Central Avenue Improvements Columbia Heights Municipal Consent Public Hearing Questions

Christopher Bower | North Area Engineer

July 27, 2026

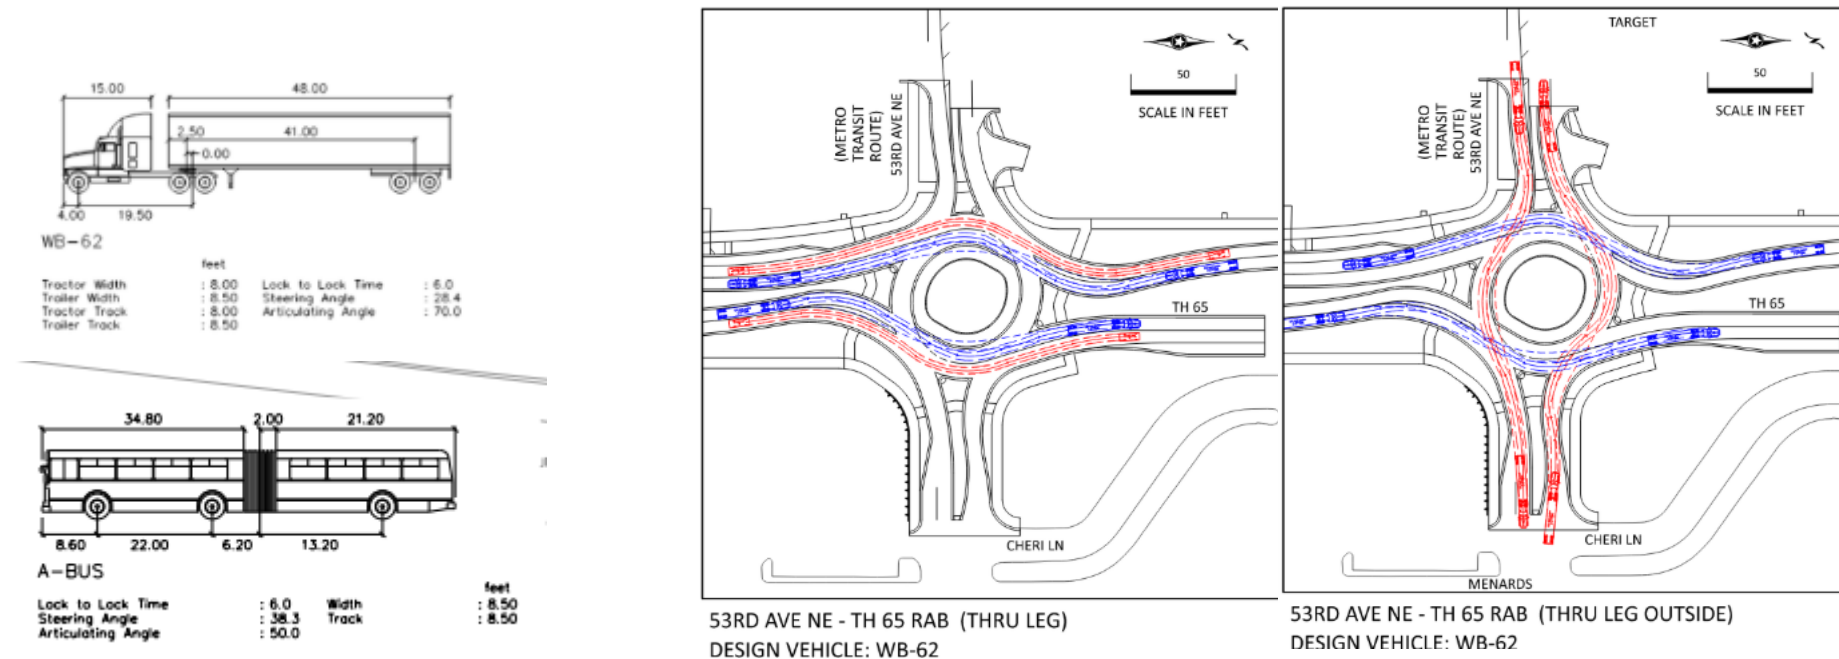
Q12. How will the project ensure businesses that currently have parking continue to have parking?

MnDOT is not proposing major changes to the on-street parking along Central Avenue. Generally, where parking exists today, parking will be maintained.

At intersection corners, parking will be restricted immediately adjacent to the intersection to maintain clear sight lines at the intersection. This will result in the removal of a small number of parking spaces immediately at the intersections, but the balance of parking on the block will be maintained.

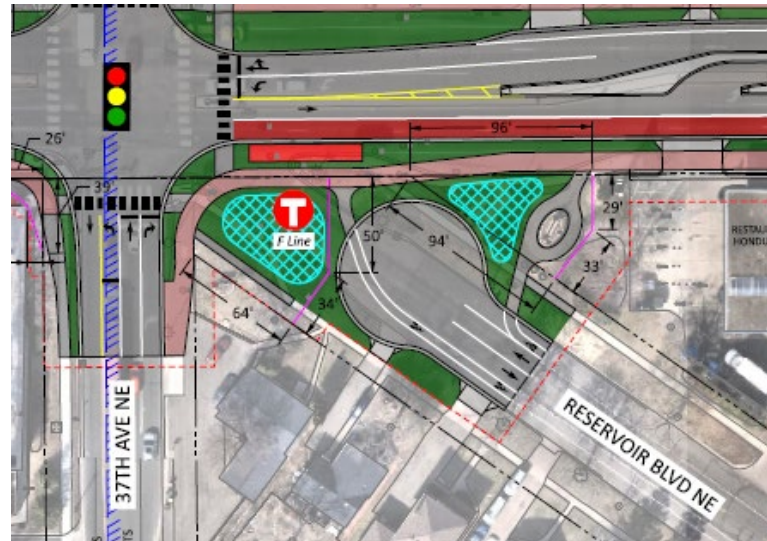
Q27. Why are signals needed at 50th and 52nd for cars only turning right?

The primary reason that traffic signals are proposed at 50th and 52nd Avenue is to maintain a signal-controlled pedestrian crossing of Central Avenue. MnDOT doesn't typically install pedestrian-only traffic signals, but in this instance, it's important to provide a signalized crossing opportunity for pedestrians who are blind or low vision and may not feel comfortable crossing at the roundabout at 51st or 53rd.

If MnDOT installs a traffic signal for pedestrian crossings, the added cost to signalize the right turns is minimal. It also adds the ability to display a red turn arrow on 50th & 52nd when a pedestrian is crossing Central Avenue to minimize conflicts between right-turning vehicles and pedestrians.

MnDOT traffic modeling suggests the signal is not needed for right-turning motor vehicles. We would not propose constructing a signal here for that purpose alone.

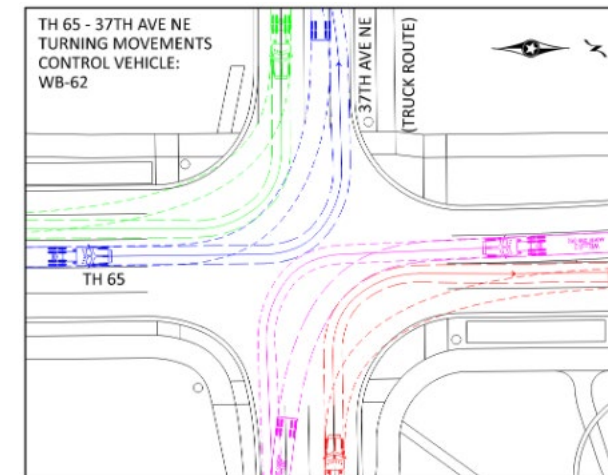
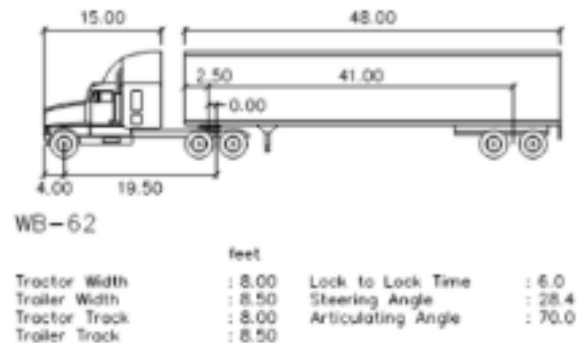
C20. Concerned about trucks being able to get in and out along Central, having the biggest trucking terminal just south of the golf course.

The proposed layout was developed using a WB-62 vehicle which is a standard interstate semitrailer that has a 53-foot trailer and 62.5' between wheelbase. MnDOT will continue to work with businesses on vehicle access needs.
